**RESPONSE TO KEY ISSUES LETTER
V BY CROWN | 45 MACQUARIE STREET, PARRAMATTA**

We write in response to the Department of Planning & Environment's (DP&E) letter of 10 December 2014, relating to 45-47 Macquarie Street and 134-140 Marsden Street, Parramatta (V by Crown) and MP09_0167 MOD4.

Figure 1 – Amended design reflecting upper level setback in Section D
Source: AJ + C

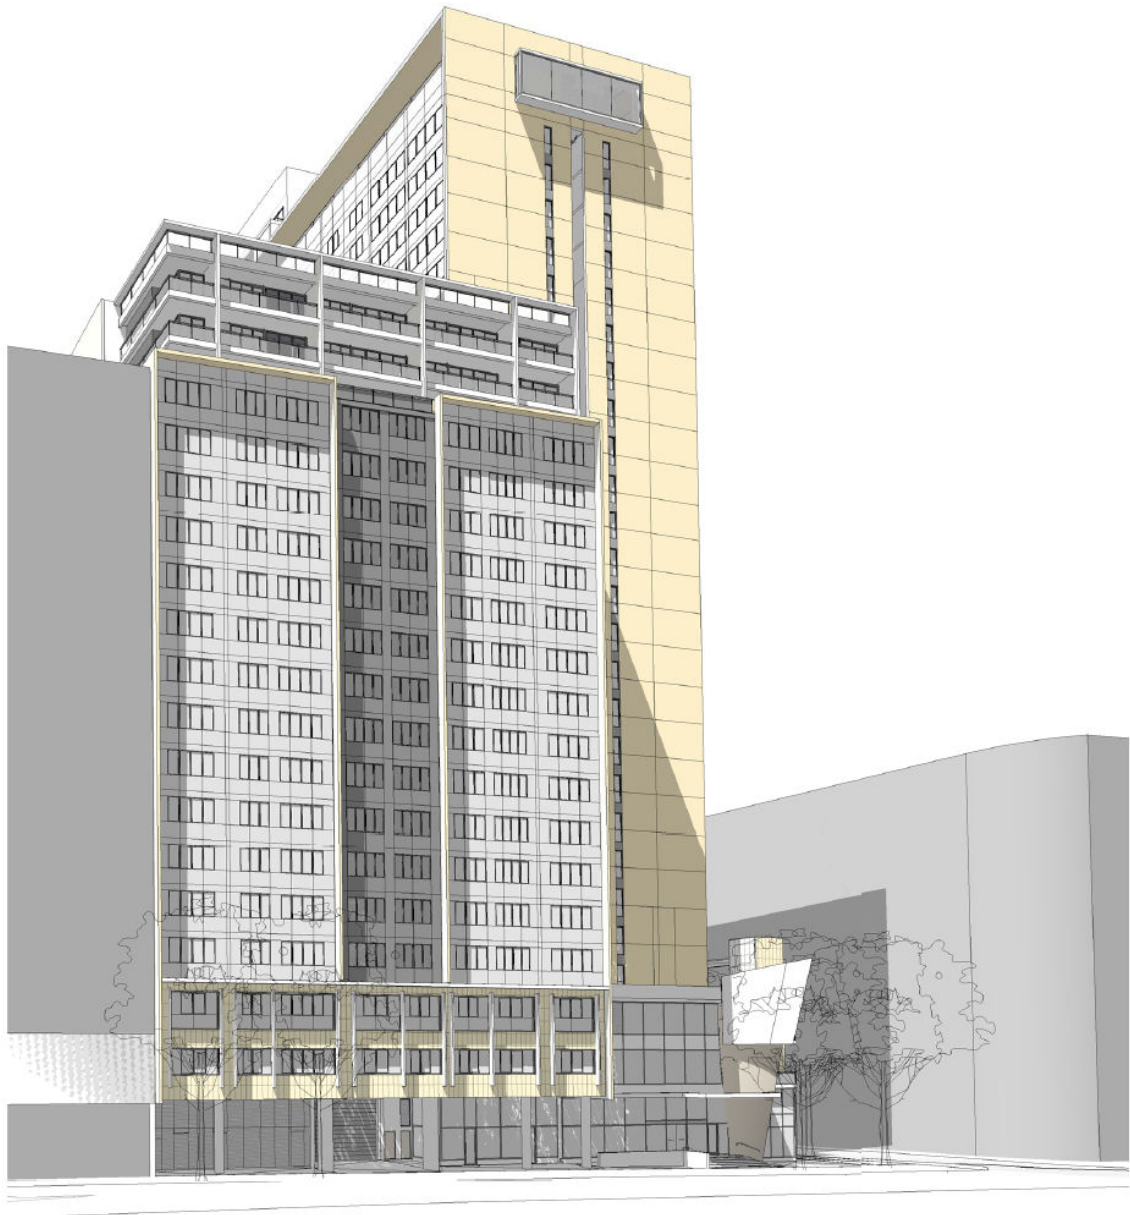
- a) **further consideration of the architectural approach to the Hunter St façade (up to 54m).** *The division of the façade is an appropriate method of articulation and visually emphasises verticality. However, the central strip, which includes a colour/material change, contrasts poorly within the context of the overall design of the development and this element is unlikely to have the same visual benefit / be read in the same way as the deep recesses on the Marsden Street elevation.*
 - *a potential alternative option could be to divide the elevation in half and provide two projecting wrap-around features which are separated by an expressed gap (eg attached).*
- b) **addition visual interest to the blank flank wall (east) (above 54m).** *The colour/material change of the wall at this level is acceptable. However, the wall's unrelieved blank nature is likely to draw undue attention.*

- *a potential alternative option could be to insert a column of windows (offset from those below) into the wall.*

In our view, the wider strip better achieves the desired articulation. Further, placing the two frames close together would require additional structural support, as they would not connect to the other pre-cast concrete walls behind. As a middle ground, AJ + C have replaced all fixed glass in this strip with dark-coloured glazing. This should serve to increase contrast and emphasise the division and verticality of the façade.

AJ + C have considered the proposal to add windows to the eastern face of the south-facing frame and believe that a solid frame is more consistent with the adjacent solid frame of the south-facing Marsden Street façade. Therefore, it is proposed that this façade remain solid and unchanged.

Figure 1 shows the amended design.

3. A notional 54 metre massing has been added to the attached views (and is shown in **Figure 1** above).
